**CERTIFICATE OF APPROPRIATENESS**

**Applicant:** Garrett Stepanovich

**Property:** 769 E. 5<sup>th</sup>½ Street, Lots 4,5,6,7, Block 4, Freeland Subdivision. The property 7,181 square foot corner lot.

**Proposal:** New Construction – Two story primary residence with one story detached garage

**SOUTH ELEVATION – FRONT FACING E 5<sup>TH</sup>½ STREET – PROPOSED**

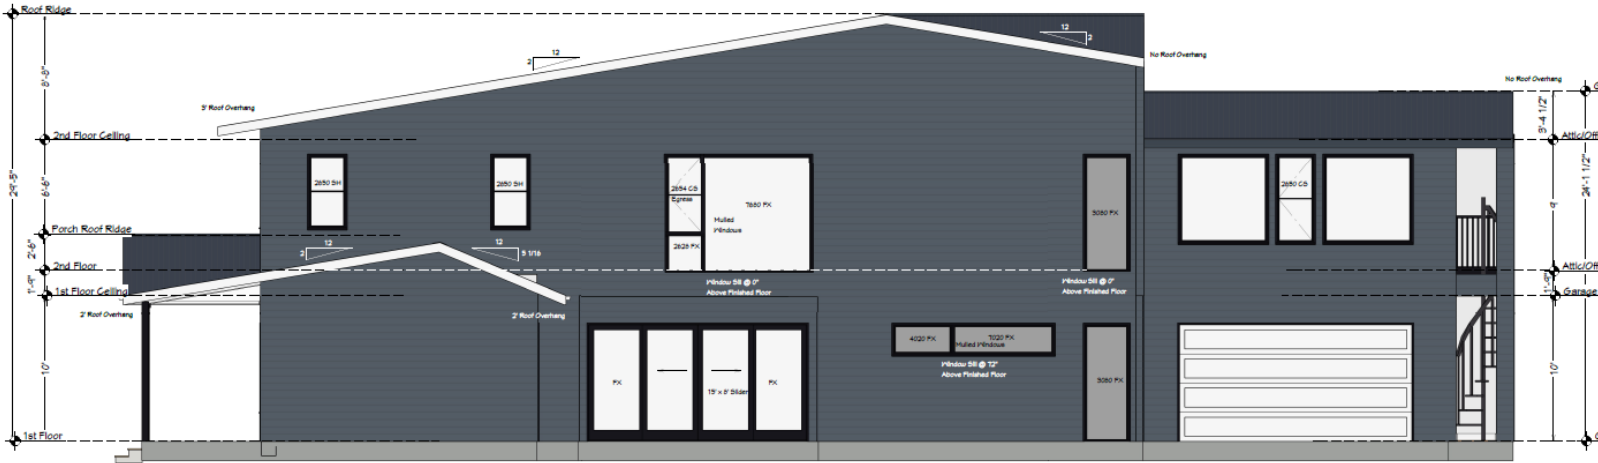
| <input type="checkbox"/> | <input checked="" type="checkbox"/> | <input type="checkbox"/> | (2) The exterior features of the new construction must be compatible with the exterior features of existing contributing structures in the context area;<br><span style="color: red;"><i>Exterior features of proposed design are not compatible with contributing structures in the context area (primary 1-story bungalows of under 2,000 sq ft). The asymmetrical roof pitch, profile, eaves, length, and overall massing are distinctly different to that of contributing context. Contributing context sharing the property line, for instance, is 6:12 and has a secondary pitch of 12:12, the recent addition for that property has a 6:12 pitch The proposed pitch on this project is 2:12. In addition, the window openings propose a similar problem of irregularity compared to the existing contributing context. The front door form is also atypical. All other contributing buildings in Freeland are one or one and a half story bungalows on the front elevation, while the proposed new construction is two story. (see criteria 4)</i></span> |
| <input type="checkbox"/> | <input checked="" type="checkbox"/> | <input type="checkbox"/> | (4) The height of the new construction must not be taller than the typical height of existing contributing structures in the context area unless special circumstances, such as an atypical use, location, or lot size, warrant an atypical height, except that;<br><span style="color: red;"><i>Typical height in Freeland is that of a one or one-and- half story bungalows. The immediate contributing context at 709 has a <b>historic ridge height of 17'7."</b> In 2017, they received an HAHC approved COA for a two-story addition at the rear with a ridge height of 26'-10 1/2," <b>proposed ridge height for this project is 29'-5."</b></i></span><br><br>(a) Design guidelines for an individual historic district may provide that a new construction with two stories maybe be constructed in a context area with only one-story contributing structures as long as the first story of the new construction has proportions compatible with the contributing structures in the context area, and the second story has similar proportions to the first story; and ( <span style="color: red;"><i>Freeland does not have design guidelines.</i></span> )<br><br>(b) A new construction shall not be constructed with more than one story in a historic district that is comprised entirely of one-story contributing structures, except as provided for in design guidelines for an individual historic district.<br><span style="color: red;"><i>Freeland is comprised of one or one and half story bungalows (with front ridge heights +/-17'). Some of the contributing buildings have second story rear additions, but none of them have a two-story front façade. Freeland does not have design guidelines.</i></span> |

**WEST SIDE ELEVATION**  
 PROPOSED

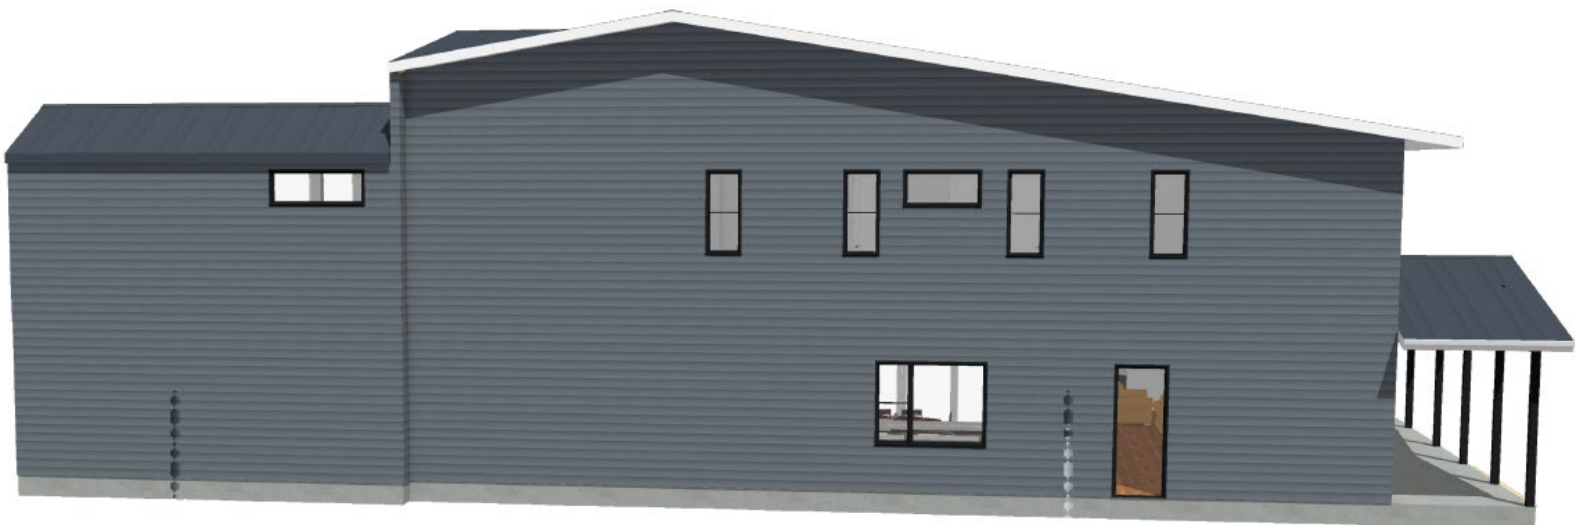
| <input type="checkbox"/> | <input checked="" type="checkbox"/> | <input type="checkbox"/> | (1) The distance from the property line of the front and side walls, porches, and exterior features of any proposed new construction must be compatible with the distance from the property line of similar elements of existing contributing structures in the context area;<br><span style="color: red;"><i>West setback is 3'11" – typical setbacks are around 5 ft or more</i></span> |
